REGISTRY OF RADIOACTIVE SEALED SOURCES AND DEVICES  
SAFETY EVALUATION OF DEVICE  
(AMENDED IN ITS ENTIRETY)

NO.: NR-348-D-111-B

DEVICE TYPE: Electron Capture Detector

MODELS: G1223A, G1533A, G2310A, G2330A, G2397A, G2398A, G2404A,  
and G2405A (Generally Licensed)  
G1224A, G1536A (Specifically Licensed)

ATTACHMENT 2

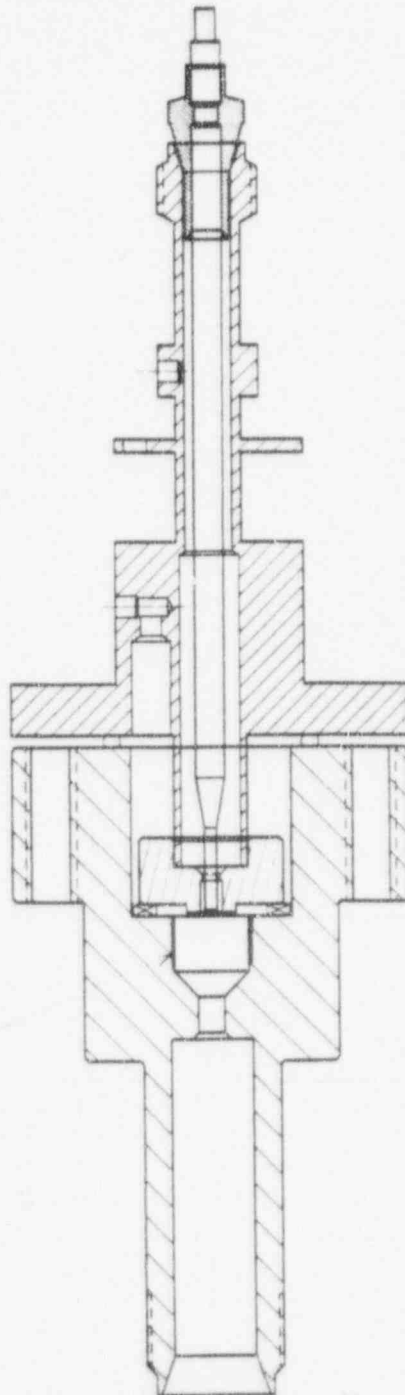
Models G2397A, G2398A, G2404A, and G2405A are almost identical to the ECD's described above. These ECDs still contain up to 15 mCi of Ni63, but instead of being plated onto the lower cell body the radioactive material is plated on a thin nickel cylinder. The cylinder is then press-fitted into the stainless steel lower body.

ATTACHMENT 2

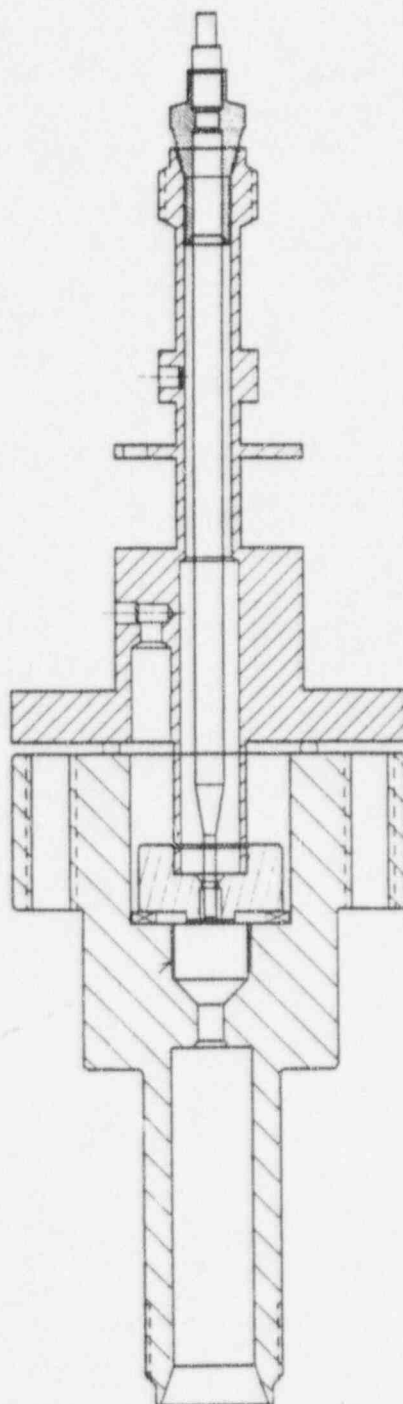
In answer to your question regarding possible scrape-off contamination during the press fit process of the Ni63 plated cylinder. The Nickel is a medium-hard electroplate and the wall thickness of the cylinder is thin enough so that it partially collapses to conform to the shape and size of the cavity of the lower body of the ECD (Electron Capture Detector). This flexibility of the cylinder should provide very little surface friction, which should prevent all but insignificant amounts of scrape-off.

The cylinders are manufactured by Dupont Merck Radiopharmaceuticals of North Billerica, MA, and they also insert the cylinders into the lower body of the ECDs. After they complete the insertion of the cylinders a wipe test (smear test) is performed on all inactive surfaces and the contamination shall not exceed 0.0006uCi.
